IN THE DRAWINGS:

REMARKS

FIGURE 3

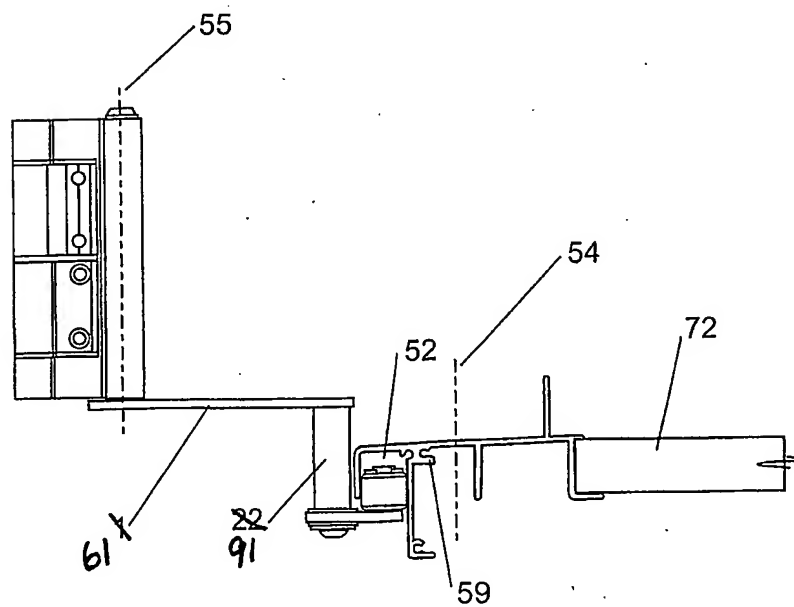
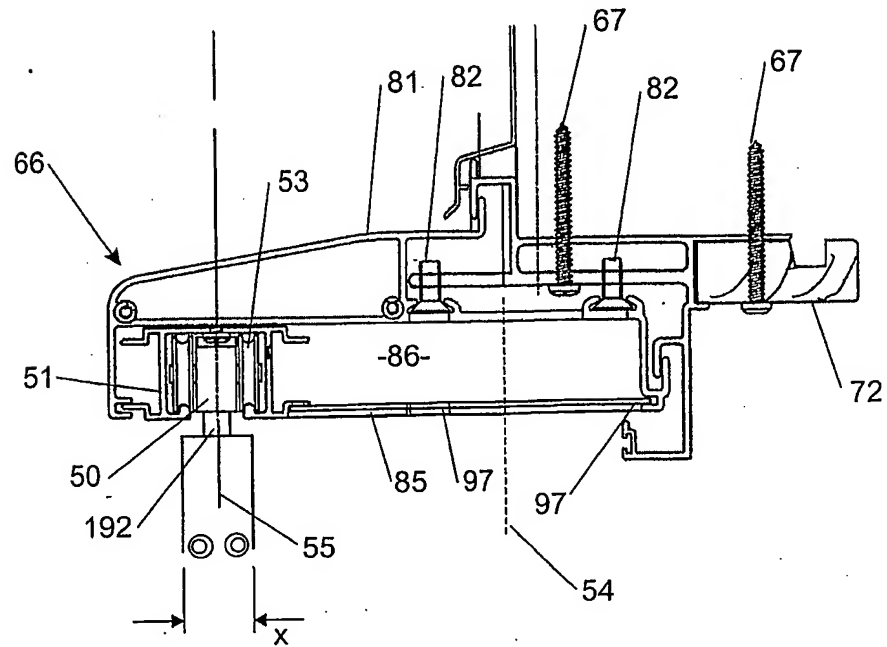
The attached annotated sheets show changes to Figures 3 and 10.

Replacement sheets of Figures 3 and 10 also are attached.
